MEMORANDUM

RE: Response to comments for C&D Landfill
NC Solid Waste Permit #74-07

The following is a response to comments received from Donna Wilson of the Solid Waste Section via e-mail on April 16, 2009. John Tucker and I contributed to the response, with additional input from the surveyor, Tip Burgess of Burgess Land Surveys. I met with Ms. Wilson on May 6, 2009 to discuss a partial submittal, with an additional partial submittal on May 7, 2009 (as noted in an item-by-item response to the comments given below). The documents furnished thus far are attached for convenience. At present, we have responded to the comments and are waiting on a final survey and deed revision. Upon satisfactory completion of the review, we will update the electronic submittal (in pdf format). Ms. Wilson's comments and my responses are given below:

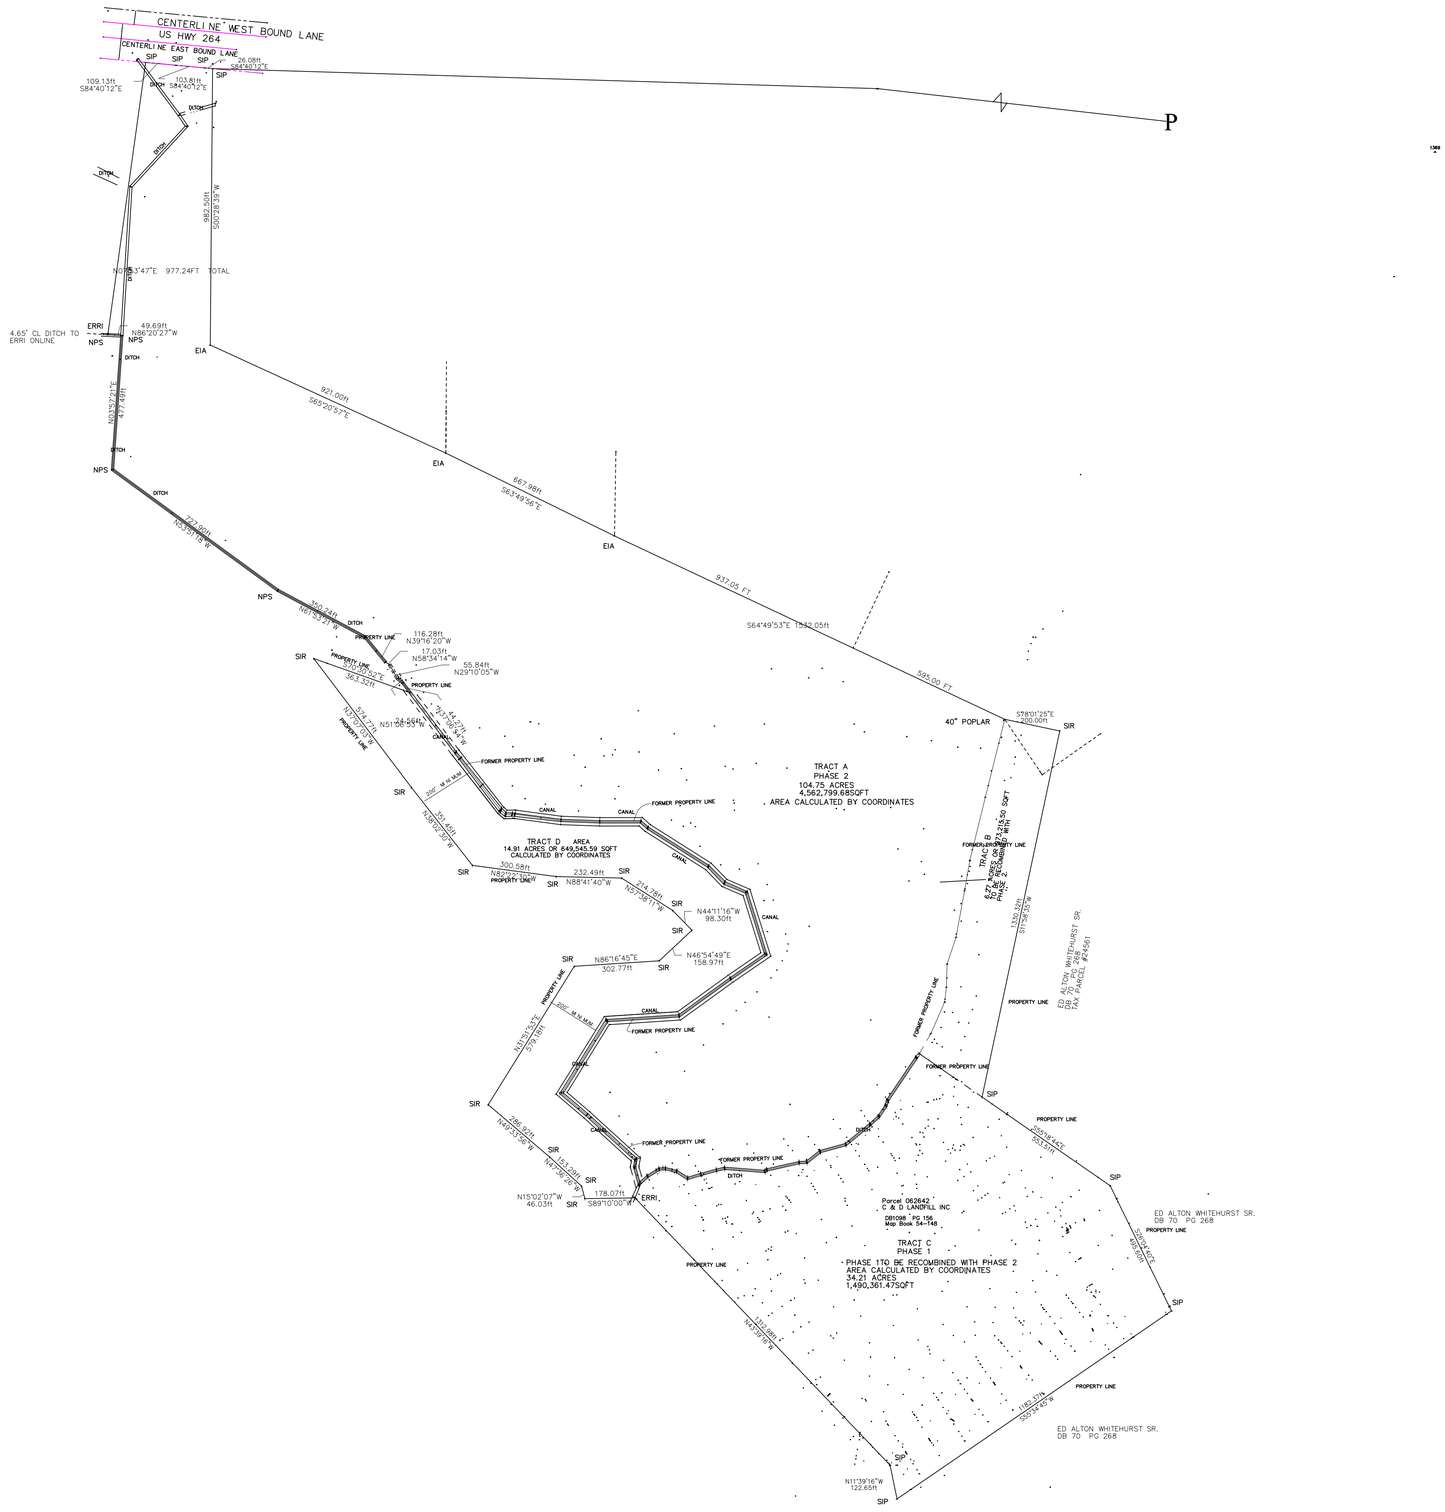
1. Of the nine land deeds submitted, one deed appears to be for the
      Phase 1 property, and one appears to be for the entrance
      parcel/transfer station, but the other 7 deeds appear to be
      unrelated to the landfill. Please clarify. Please provide the land
      deed to the Phase 2 property. I believe it is most likely Deed
      book 1105, page 306.
```

2. The Phase 1 property, the Phase 2 property, and the added buffers on the east and west sides of Phase 2 must be recombined to one landowner, and one parcel. Please provide a copy of the two land deeds for the recombination property on the east and west sides of Phase 2, in which the property is combined with the Phase 2 property, and a copy of the recombination map recorded at the register of deeds for the recombined property. Phase 1 and Phase 2 property must also be combined because otherwise there must be a 200 foot buffer from the Phase 2 disposal area to the Phase 1 property line. The drawing submitted, adding the buffers to the east and west of Phase 2, was not signed by the surveyor.

A preliminary revised survey map showing the combined properties as one plat (with acreage) has been prepared by Tip Burgess and has been filed with the Pitt County Register of Deeds (as of May 7, 2009) in pursuit of a correction deed. Copies of the deed and plat will be forwarded to the SWS as soon as they are received. A pdf of the survey was forwarded via e-mail to the SWS on May 11, 2009. Once these documents are completed, the other nine deeds mentioned in Ms. Wilson's comments will be superseded and, thus, those deeds should be removed from the permit file.

This comment is addressed by Response #1 above. All drawings and deed documents will be signed by the appropriate parties.

C&D LANDFILL - PHASE 2
PERMIT TO CONSTRUCT
SUPPLEMENTAL WETLAND DRAWING

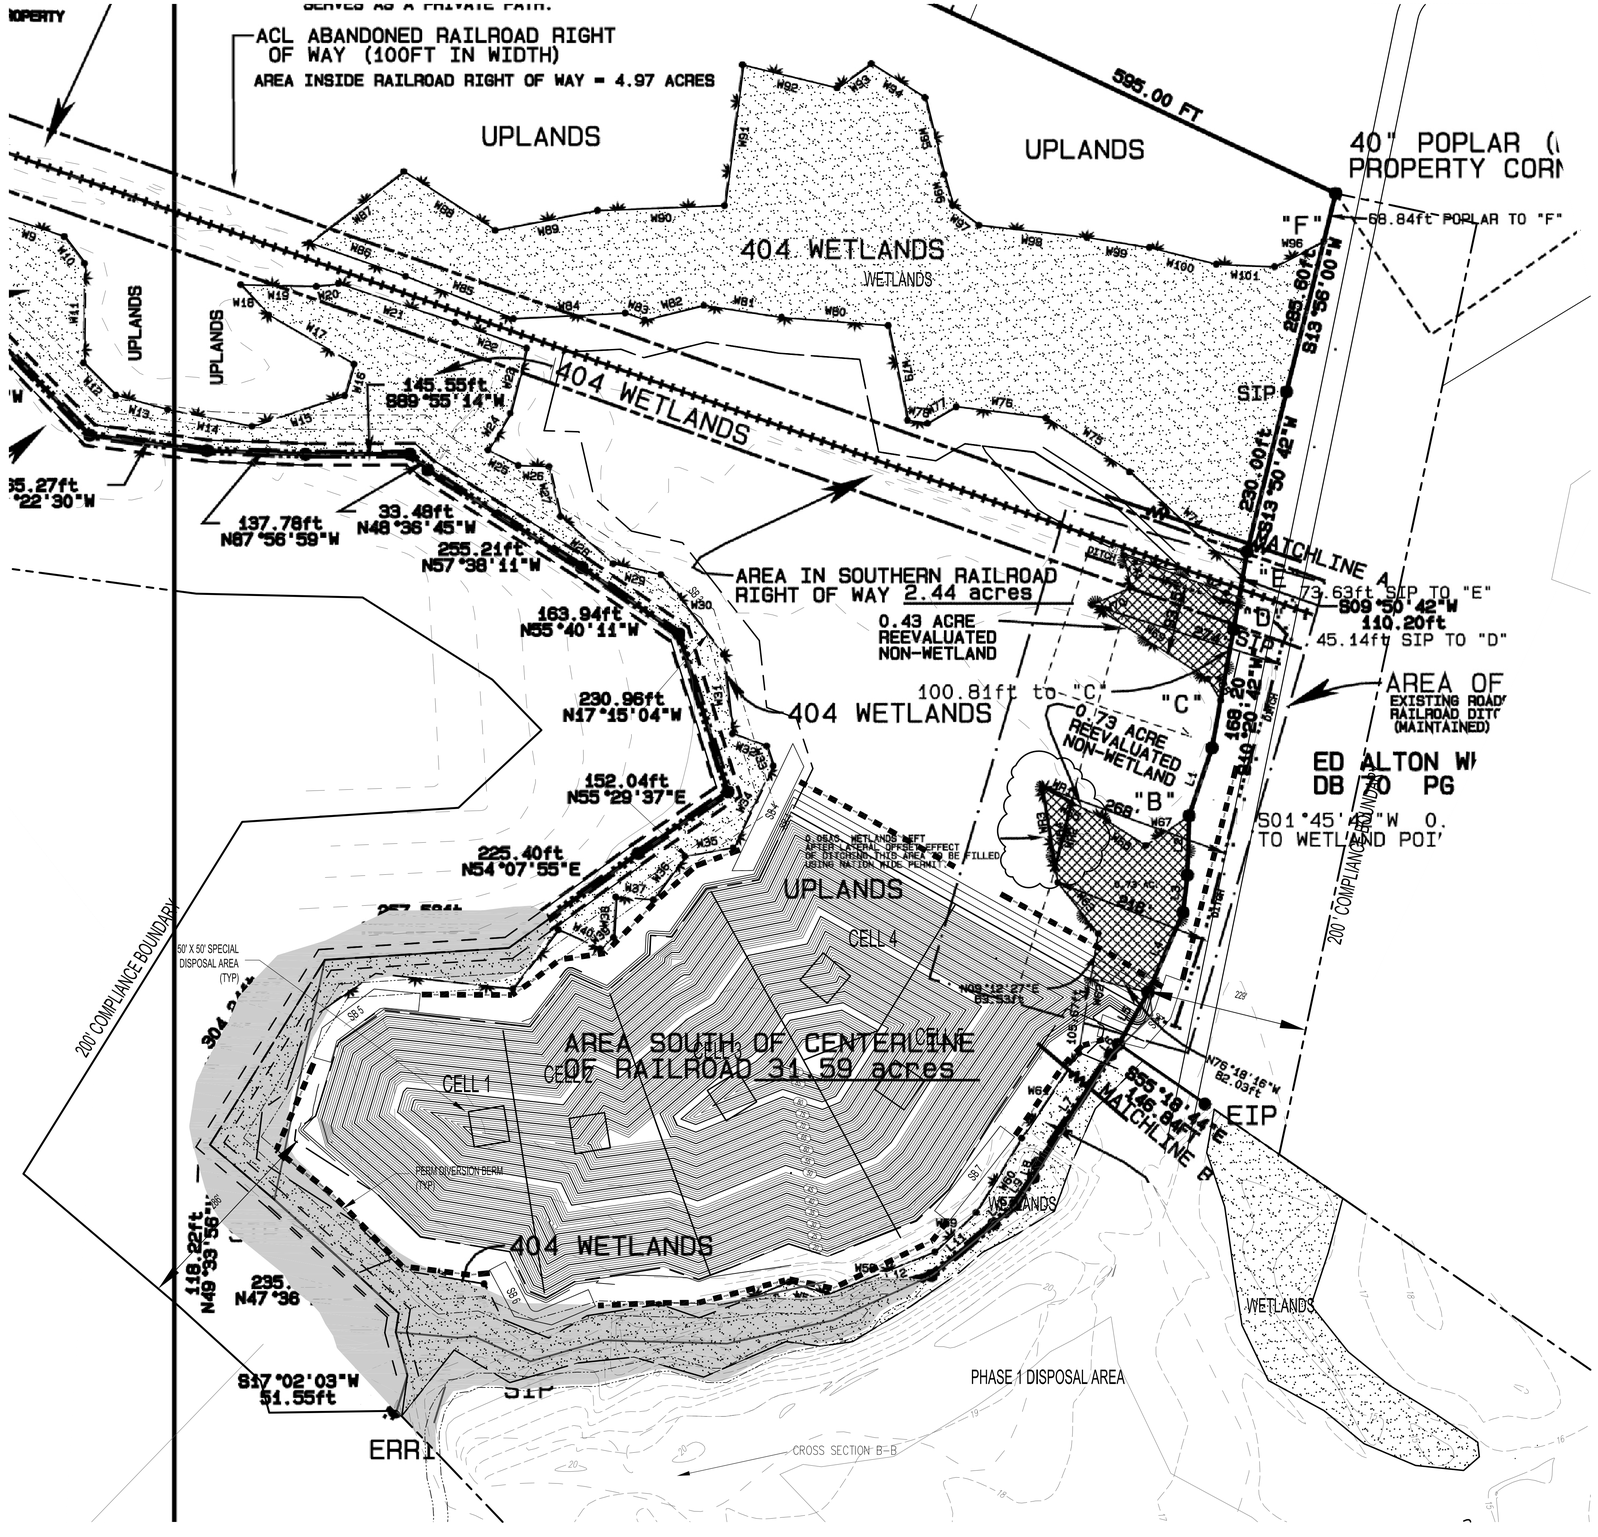
4. The drawing showing the location of the 0.05 acre wetland area in Phase 2B appears to locate the wetland area further north in the Phase than it is represented on the wetlands drawings. Refer also to drawing S4 from Nov. 2008.

John Tucker revised the supplemental drawing (originally furnished in April) by overlaying the 2003 wetlands survey, which shows the 0.05 acre area, on the footprint drawings for Phase 2A and 2B. The supplemental drawing, presented to Ms. Wilson on May 7, 2009 (see attached), clearly shows the wetlands area outside of the Phase 2A footprint, but the original submittal was in error. I anticipate that the forthcoming permit to construct (PTC) will stipulate that this area be staked and protected until further evaluations with the Corps of Engineers can be completed.

THE .05 AC WETLANDS SHOWN ON THIS DRAWING ARE TAKEN FROM AN IMAGE OVERLAY OF A MAP PREPARED BY BURGESS LAND SURVEYING, ENTITLED "WETLANDS SURVEY FOR EJE RECYCLING, INC." REVISED 08/29/2003 .
ALL PREVIOUS REFERENCES TO THE .05 AC WETLANDS SHOULD BE DISCARDED.

WETLANDS SURVEY
FOR
EJE Recycling, Inc.

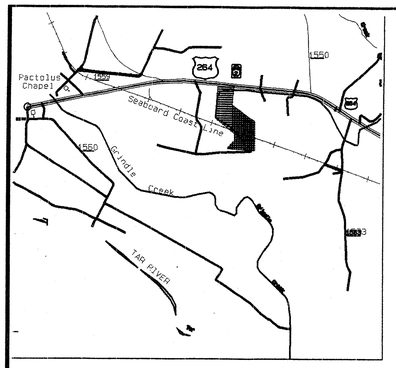
6. Please provide page 3 of 4 and page 4 of 4 for the wetlands delineation maps that apply to the 2008 reevaluation boxed area. The drawings submitted on April 3 apply to the 2003 wetlands determination.

A revised 2008 wetlands map with corrected page numbers was submitted on May 7, 2009, with input from Tip Burgess. Per my meeting with Ms. Wilson on that day, there is no page 3 or 4 for the 2008 wetlands survey.

C&D LANDFILL - PHASE 2
PERMIT TO CONSTRUCT
PHASE 2A -GRADING PLAN

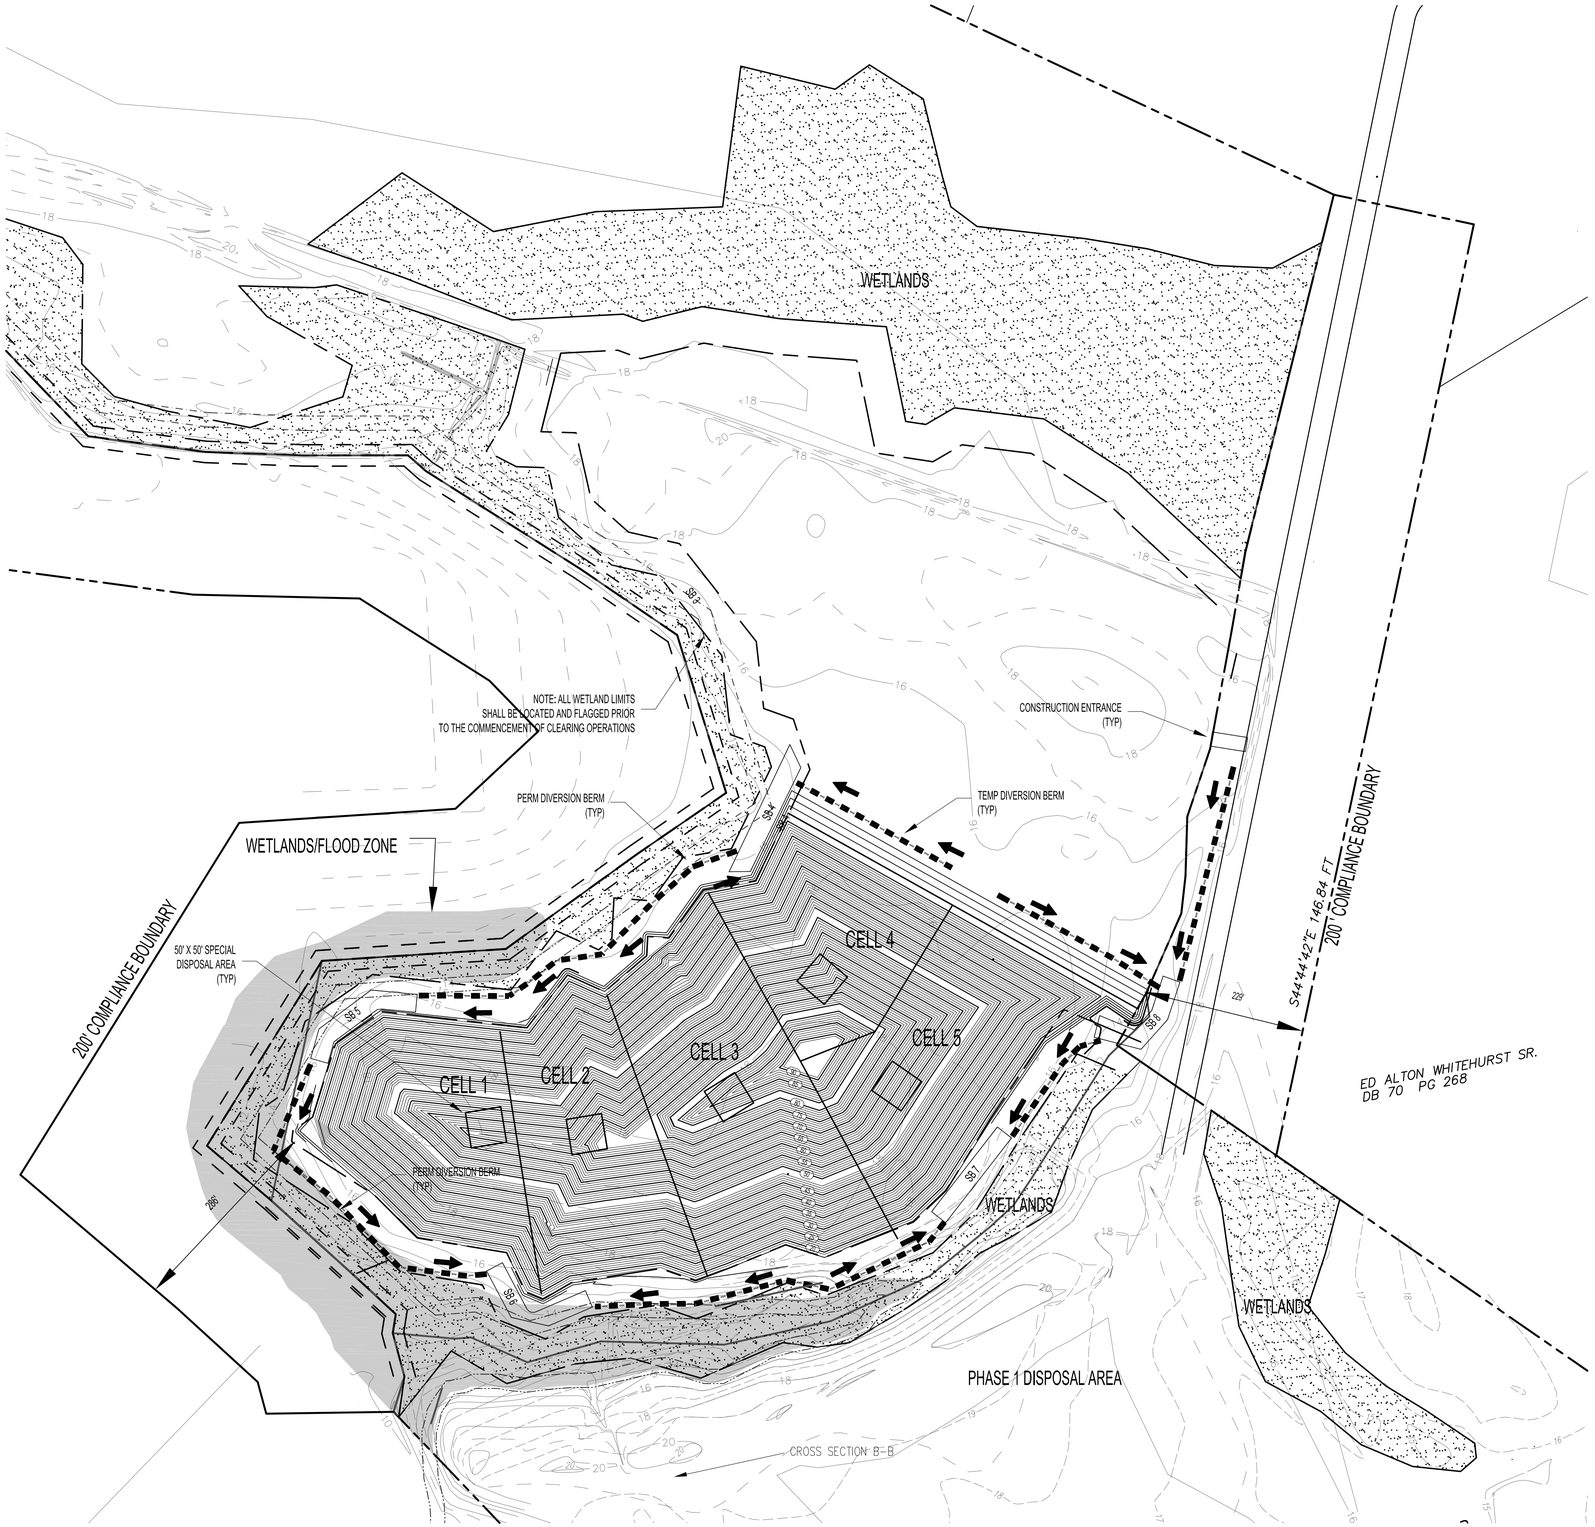
3. Please show the direction of stormwater flow around the landfill base for Phase 2.

Half-size copies of the full drawing set were presented to (and reviewed with) Ms. Wilson on May 6, 2009. The flow direction arrows have been made clearly visible at all viewing scales.

4.	STORM WATER FLOW DIRECTION ADDED	04-30-09
3.	BOUNDARY UPDATED	03-04-09
2.	REVISED PER DSW COMMENTS	02-18-09
1.	REVISED PER DSW COMMENTS	10-29-08
